# UNITED STATES PATENT AND TRADEMARK OFFICE

10/573,871

<b>Office Action Summary</b>	<b>Application No.</b> 10/573,871	<b>Applicant(s)</b> CRONIN ET AL.	
	<b>Examiner</b> JAYMI DELLA	<b>Art Unit</b> 3739

### **DETAILED ACTION**

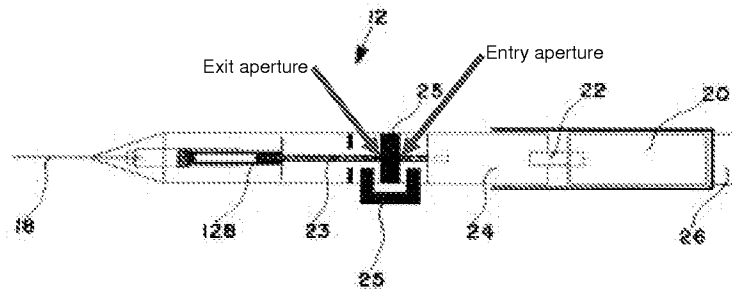
35. Concerning **claims 61-63**, Junior further discloses that the housing (25) includes at least one aperture that includes an entry aperture, through which the cable enters the housing and an exit aperture, through which the cable exits the housing, that permits **substantially** linear motion of the cable relative to the housing as illustrated in annotated Fig. 2 below.
